STAFF REPORT

SUBJECT: Pathways – AZ, CUP
[H-2023-0061](#)

I. PROJECT DESCRIPTION

B. Proposed Site Plan (dated: 1/8/24) – NOT APPROVED

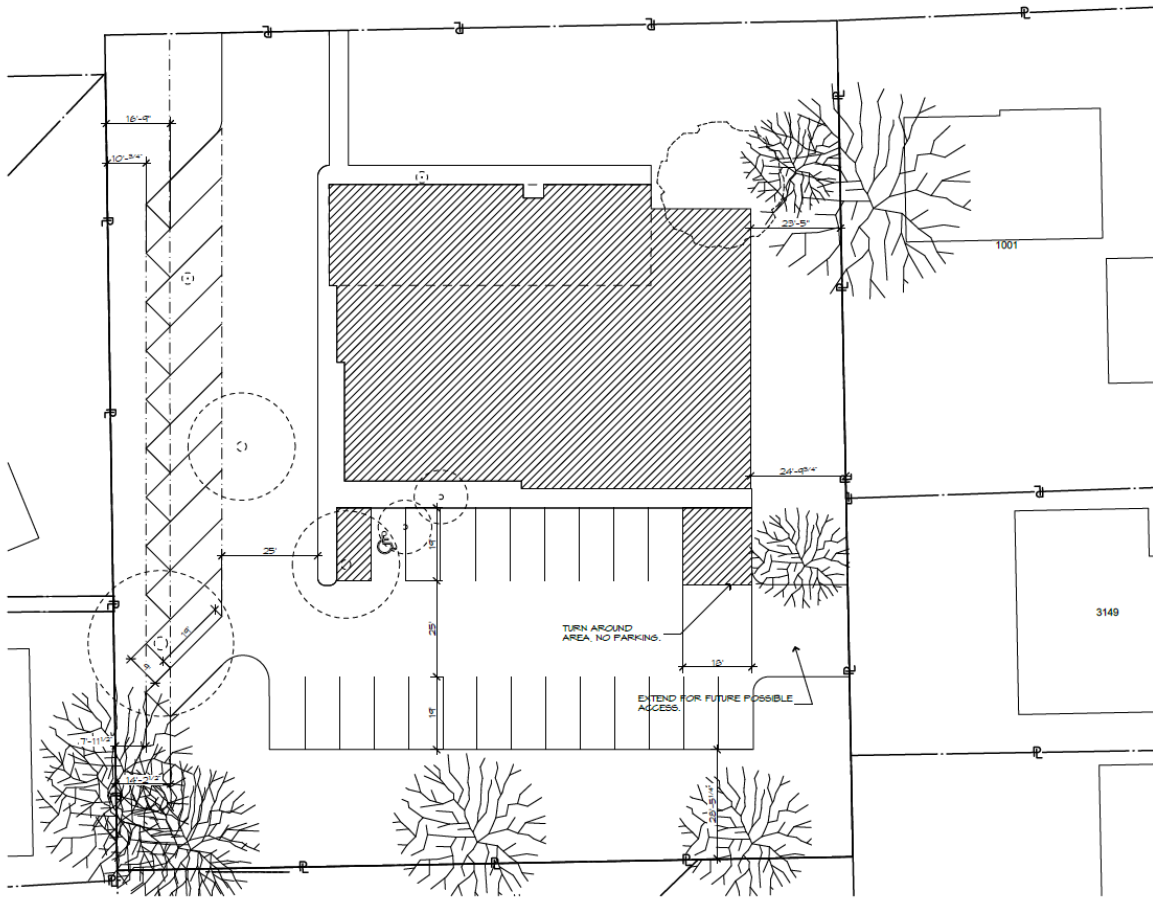
The hatched area shown on the plans at the east end of the row of parking on the south side of the building is proposed as a turnaround area.

To better facilitate traffic flow within the site, Staff recommends the angled parking along the west boundary of the site is changed to 90-degree parking, which will allow vehicles to exit the site easier without requiring them to turn around in the constrained area on the

A sidewalk is proposed on the south side of the building adjacent to parking that ranges from 5 to 7 feet in width. **If wheel stops are not provided in parking spaces abutting the 5-foot wide area to prevent vehicle overhang, the sidewalk should be widened to 7 feet in accord with UDC [11-3C-5B.4](#).** If the sidewalk is widened to 7 feet, the length of the parking spaces may be reduced to 17 feet if desired.

A 5-foot wide sidewalk is proposed from the perimeter sidewalk along Ustick Rd. to the main building entrance in accord with UDC 11-3A-19.B.4. A sidewalk ranging from 3' to 7' wide is also proposed along the west side of the building for safe pedestrian access to the main building entrance on the north side of the building. **The sidewalk should be widened to a minimum of 5 feet in accord with UDC [11-3A-17A](#).**

- 2.3 The site/landscape plan shall be revised prior to the City Council hearing as follows:
 - a. Based on the number of vehicle spaces provided, a minimum of two (2) bicycle parking spaces must be provided in a bicycle rack that meets the standards listed in UDC [11-3C-5C](#).

- d. Include a planter island at the west end of the row of parking on the south side of the building (alongside the sidewalk) that complies with the standards in UDC [11-3B-8C.2](#).

- e. Either depict wheel stops in the parking spaces on the southeast side of the building abutting the 5-foot wide section of sidewalk to prevent vehicle overhang *or* widen the sidewalk to 7 feet to accommodate vehicle overhang as set forth in UDC [11-3C-5B.4](#). *If 7-foot wide sidewalks are provided to accommodate overhang, the length of the parking spaces may be reduced to 17 feet if desired.*

- f. Include evergreen trees within the perimeter buffers to residential uses as set forth in UDC [11-3B-9C.1a](#).
 - g. Widen the sidewalk along the northwest side of the building to a minimum of 5 feet in accord with UDC 11-3A-17A.

- h. Change the angled parking along the west boundary of the site to 90-degree parking to facilitate better ingress/egress within the site. Depict 17-foot long spaces, instead of 19-foot long spaces, with no wheel stops within parking spaces.

C. Landscape Plan (dated: 1/8/24) – NOT APPROVED

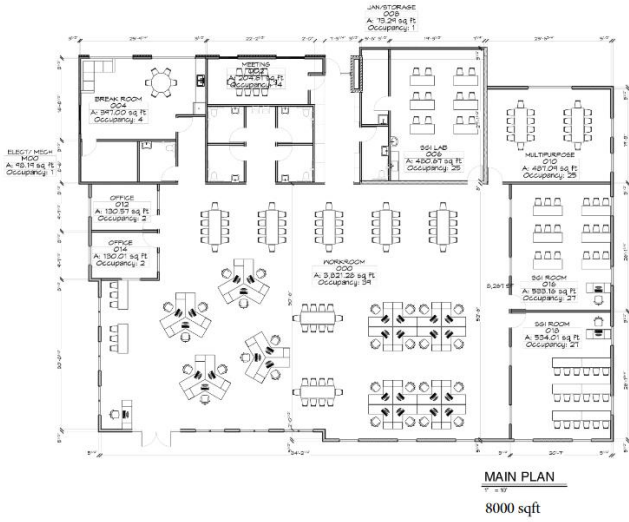
Landscaping: A 25-foot wide street buffer is required along E. Ustick Rd., an arterial street, landscaped per the standards listed in UDC [11-3B-7C](#). The tree class should be included in the Proposed Plant Material legend and should demonstrate compliance with the required standards (25% of the required trees should be Class II; and 35% of qualifying trees must provide urban canopy at maturity. The landscape plan depicts a buffer with the required number of trees and plantings in accord with UDC standards.

Parking lot landscaping is required in accord with the standards listed in UDC [11-3B-8C](#). **Class II or III trees are required in perimeter buffers; tree class should be added to the plant legend to demonstrate compliance.** Planter islands are required at the ends of rows of parking to reduce the visual impact of long rows of parked cars and to guide traffic; **a planter island should be added at the west end of the row of parking on the south side of the building alongside the sidewalk that complies with the standards in UDC 11-3B-8C.2a.**

site as set forth in UDC [11-3B-10C.5](#). There are 19 existing healthy trees on the site totaling 405 caliper inches, 11 of which, totaling 186 caliper inches, are proposed to be removed – these require mitigation. The other eight (8), totaling 219 caliper inches, are proposed to be preserved and protected on the site – these trees are proposed to be counted toward the mitigation requirement. **Existing trees being retained on the site may count toward required landscaping but do not count toward mitigation requirements; the landscape plan should be revised accordingly.**

- b. Revise the calculations on the landscape plan for tree mitigation in accord with the standards listed in UDC [11-3B-10C](#). *Existing trees being retained on the site may count toward required landscaping but do not count toward mitigation requirements.*

- c. Include the tree class in the Plant Legend on the landscape plan that demonstrates compliance with the standards listed in UDC [11-3B-7C](#) (25% of the required trees in the street buffer should be Class II; and 35% of qualifying trees must provide urban canopy at maturity and [11-3B-8C.1b](#) (Class II or III trees are required in perimeter buffers).
